NIBLEY CITY COUNCIL MEETING AGENDA Thursday, February 16, 2017 – 6:30 p.m. Nibley City Hall 455 West 3200 South, Nibley, Utah

Nibley City Council Agenda Report for February 16, 2017

Description	Discussion and consideration of a building design and site plan review for Heritage Vet Clinic/Kennel located at 2365 S Heritage Drive
Department	Planning
Presenter	Stephen Nelson, City Planner
Applicant	Jim Miller
Background	By way of general comment, in the past, when a site plan has been for a single, small building, the opinion and direction of the Council and Planning Commission has been that a concept presentation could be waived and that preliminary and final site plan could be done as one approval. The approval being requested at this time is the final site plan and building design.
	Heritage Vet Clinic/Kennel is a small-animal vet clinic being proposed to be constructed at 2365 S Heritage Drive. This property is zoned Commercial. A small-animal vet clinic is listed as a conditional use in the commercial zone. That conditional use permit is not on the agenda at this time and would be considered by the planning commission at the time of businesses licensing.

EXTERIOR ELEVATIONS

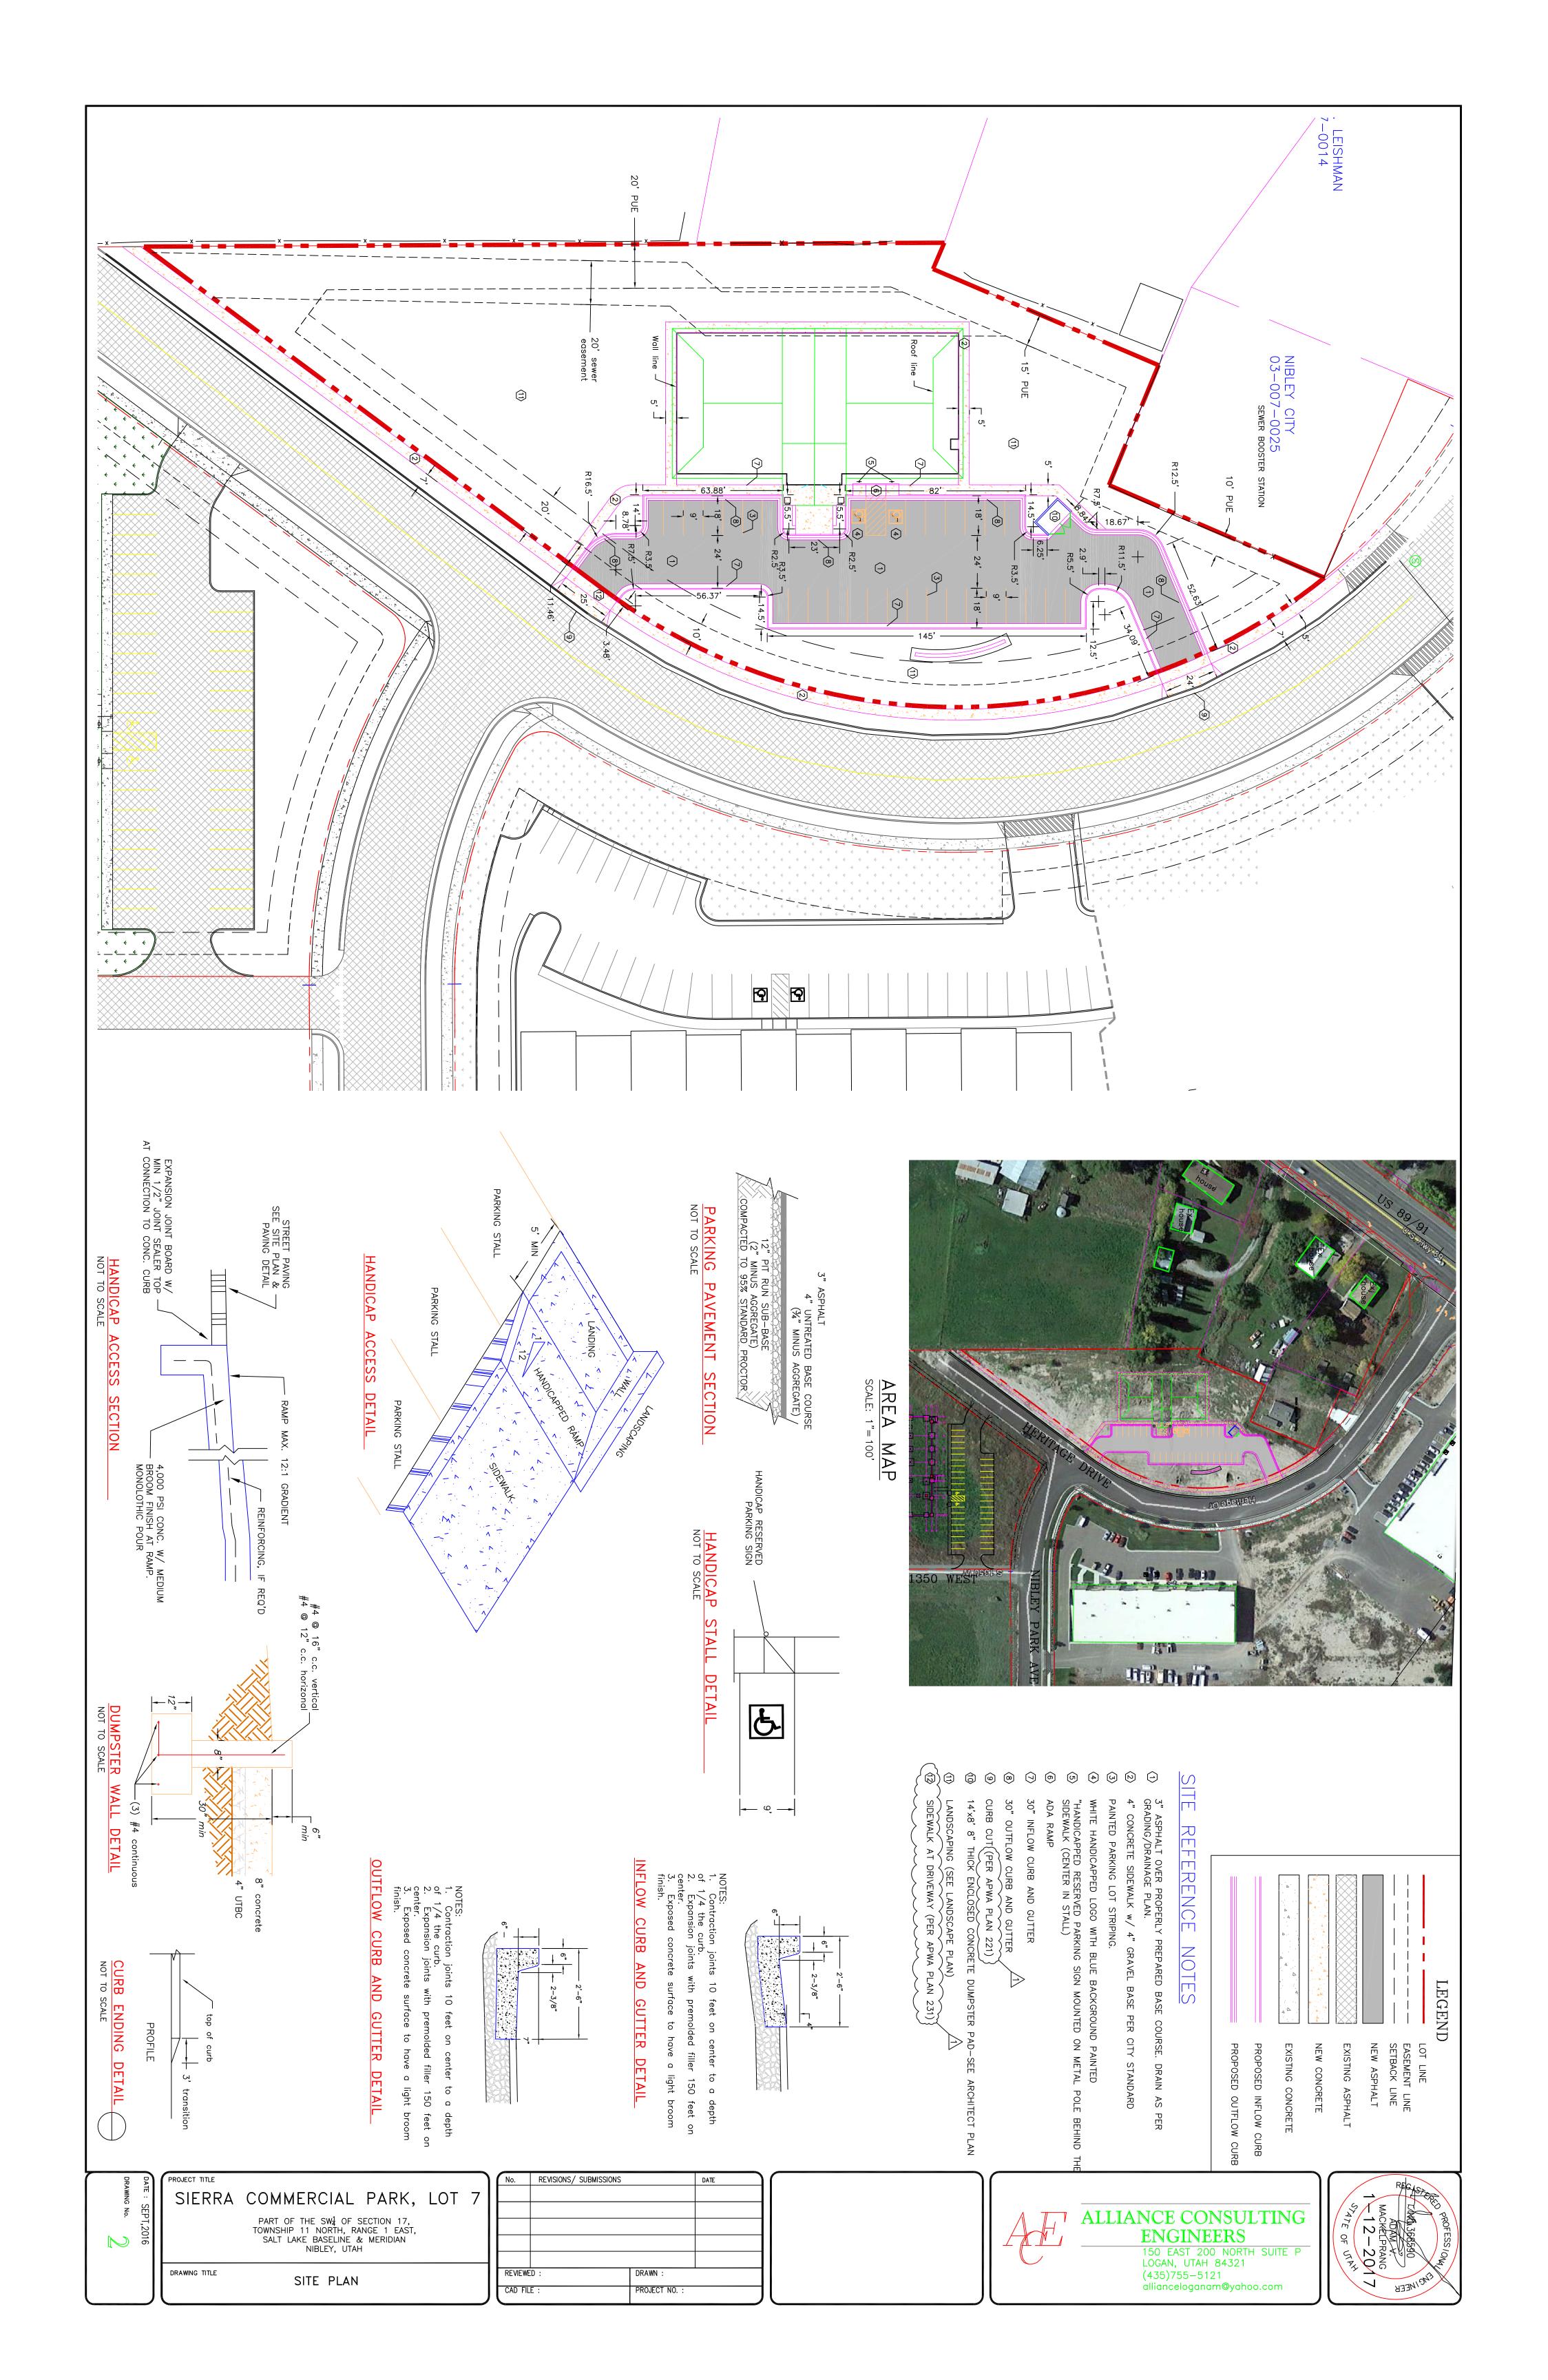
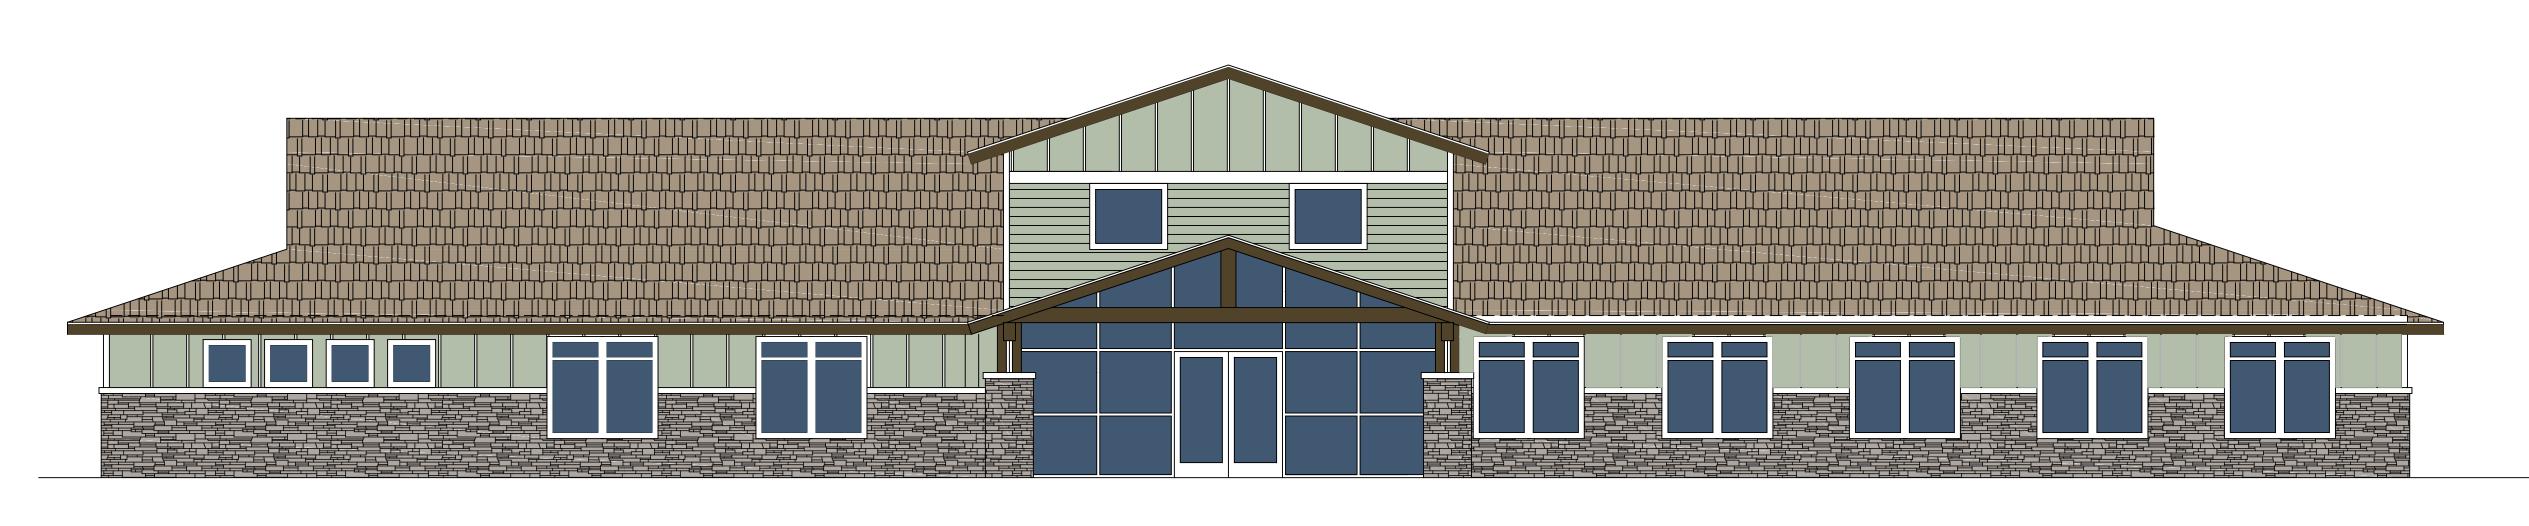
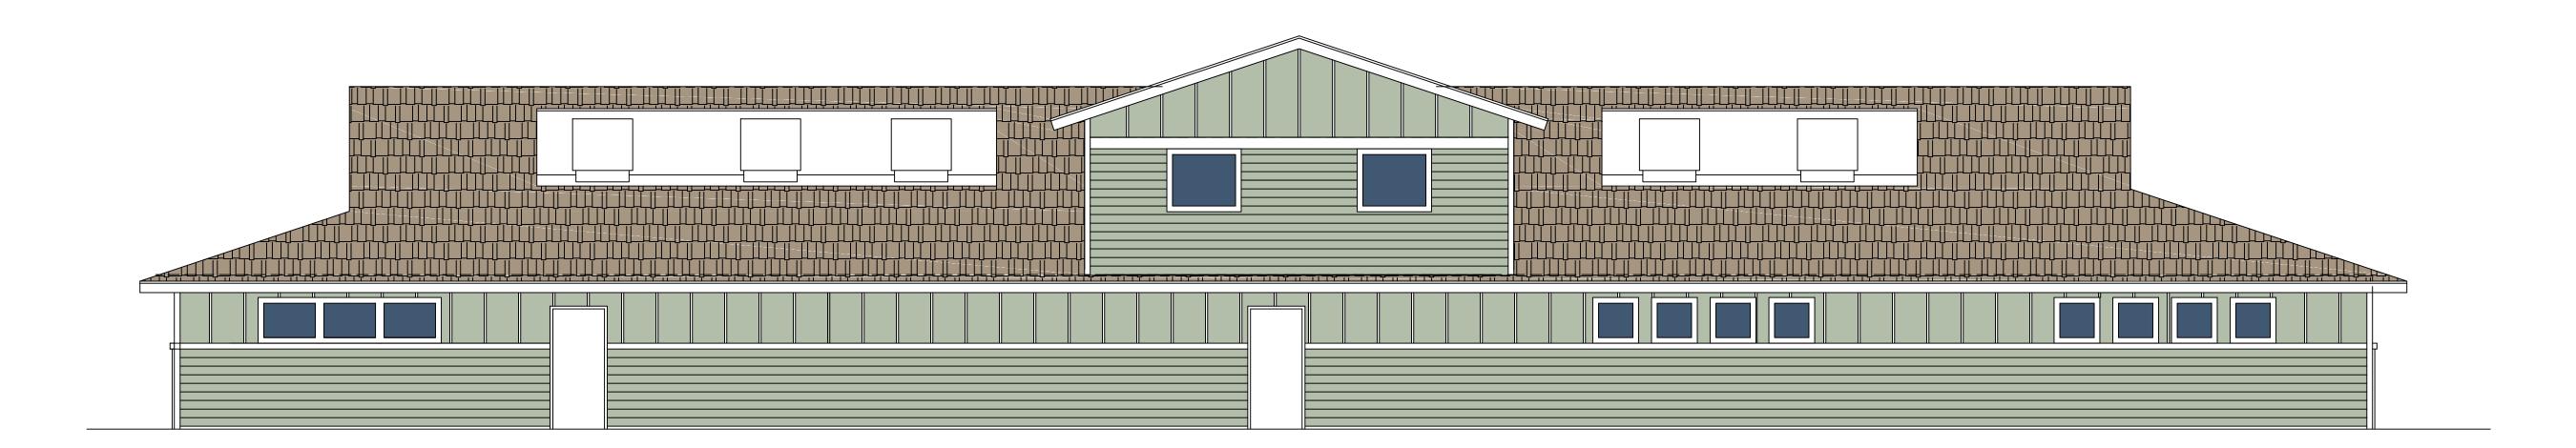
Currently, along the front elevation, the gross exterior façade is 1,157 sq. ft. and fenestration is 482.5 sq. ft. with a total of 41.7%. Nibley City Design Standards for Commercial Building requires that that front façade of commercial building has at least 60% fenestration. The building does not comply as proposed and will need to be addressed.

The standards do give the governing body some discretion and flexibility to apply the code differently for unique developments. Staff has provided a letter to the Council from the property owner addressing these concerns and asking for deviation from the standard. His primary reason for the request is privacy and safety for the animals. It is staff's opinion that the design of the building matches the intent of the law and will match the surrounding development. The Planning Commission waived the requirement for 60% fenestration at the façade of the building on January 25, 2017.

grant a variance to these standards at their discretion. The Planning Commission waived the requirement for 60% fenestration at the façade							
	of the building on January 25, 2017	-						
Recommenda	Approve the proposed site plan and design, with a modification of the 60%							
tion	fenestration requirement down to 40% ar							
	trees in the landscaping along the sewer e							
Reviewed By	City Planner, City Manager, City Engineer, City Building Inspector, Nibley City Plannir	•						
	City Dullang inspector, Misicy City Flamin	19 001111111331011
